Detailed Site Plan

6400 America Boulevard

DSP-21006

SUBJECT: Detailed Site Plan DSP-21006
Type 2 Tree Conservation Plan TCP2-031-2021
6400 America Boulevard

BICYCLE AND PEDESTRIAN EXHIBIT

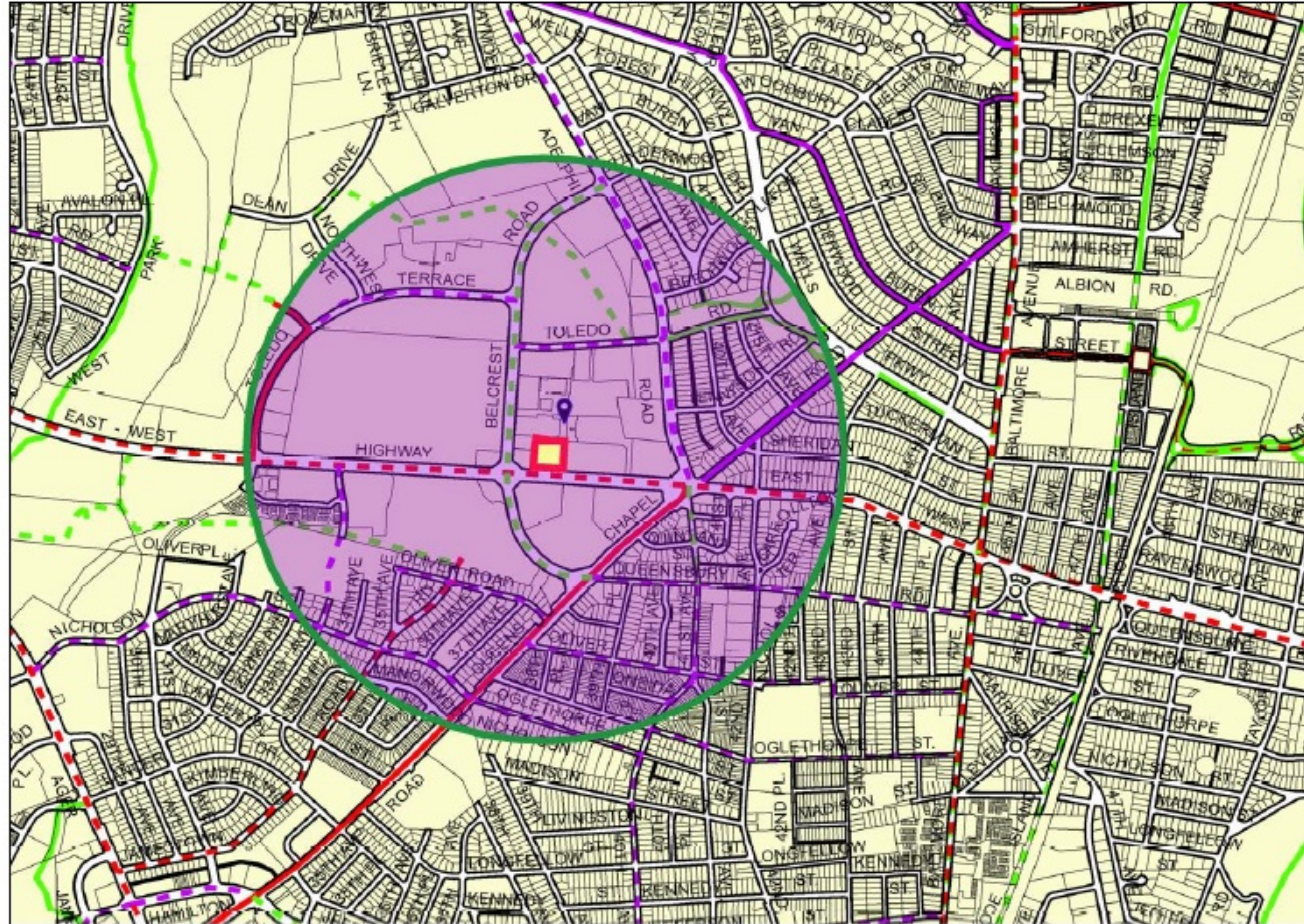
The planner recommends that details of a bicycle rack be provided and indicated that an inverted U-style bicycle rack, or a rack of a similar style that provides two points of contact to support and secure a parked bicycle is appropriate.

- n. Provide the location and amount of on-site bicycle parking on the DSP.
- o. Provide a detail sheet indicating bicycle racks to be inverted U-style or a similar model that provides two points of contact to secure a parked bicycle.

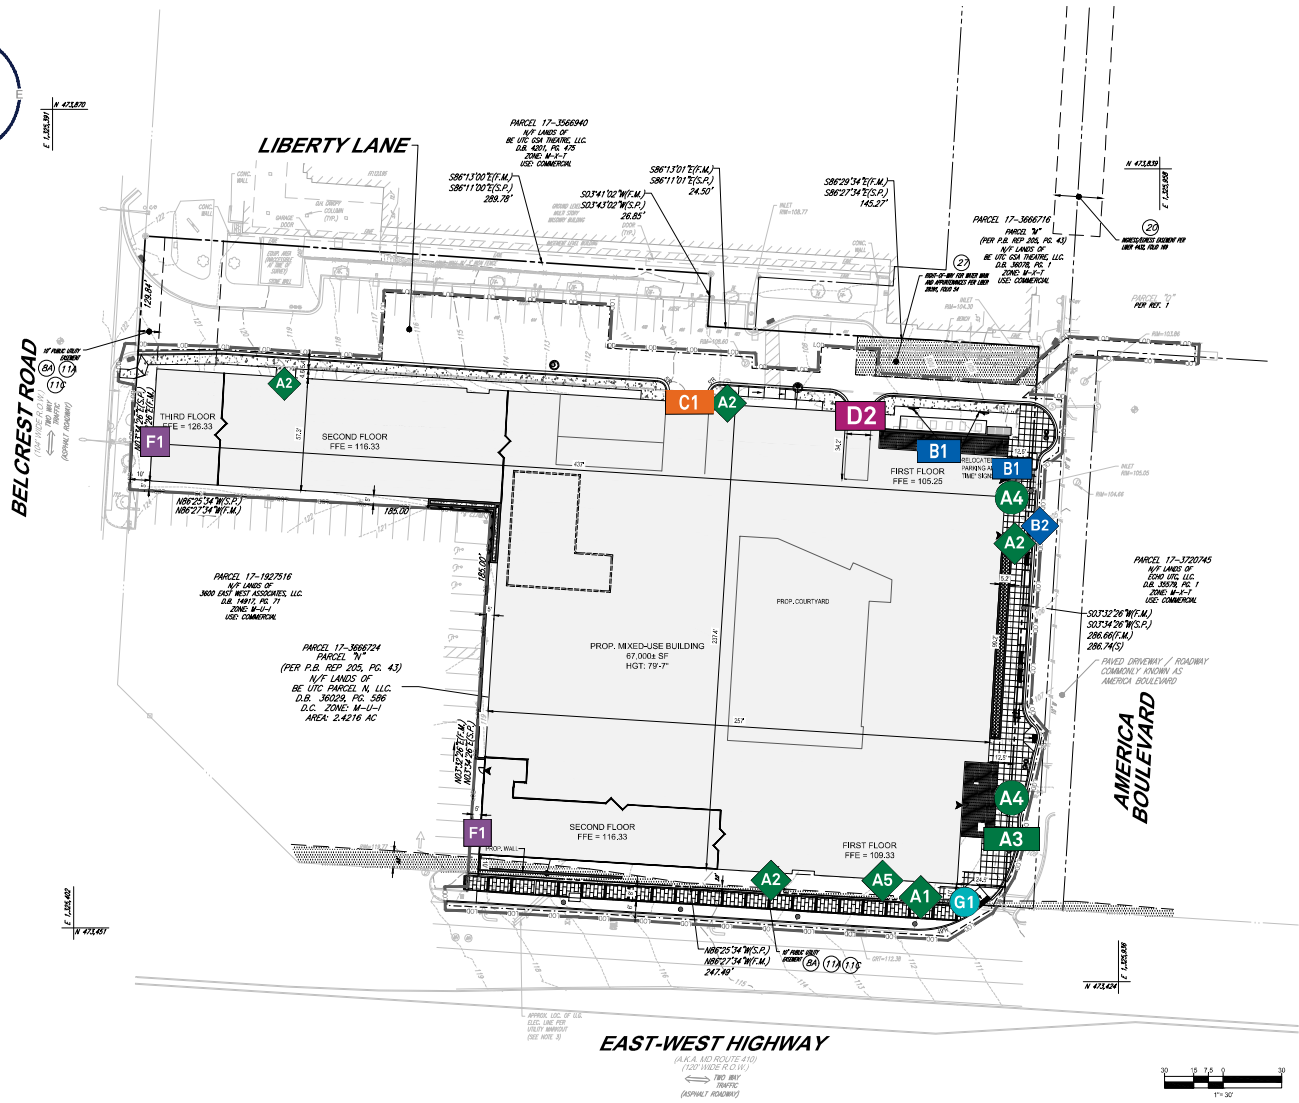
Proposed: High-rise building identification signs are permitted on buildings 7 stories tall or greater with frontage on East-West Highway

The proposed development is located at a prominent, high-visibility location within the Prince George's Plaza Transit District. This location at the southern entrance to the "Downtown" area of the TDDP welcomes residents, patrons, and visitors entering the TDDP from Metro to the south of the Property, as well as those traveling along East-West Highway. The development's position at such a high-profile location requires identity signage to foster a sense of character and place at the southern gateway to the TDDP. Moreover, blade signage and building mounted high-rise building identity signage is necessary to effectuate appropriate branding for a high-quality, mixed-use development along East-West Highway. The proposed blade and building mounted signage will help cultivate a brand at this unique position along the perimeter of the TDDP. The proposed alternative Standard is instrumental to establishing brand and identity along East-West Highway, a six-lane Arterial right-of-way with heavy vehicular traffic.
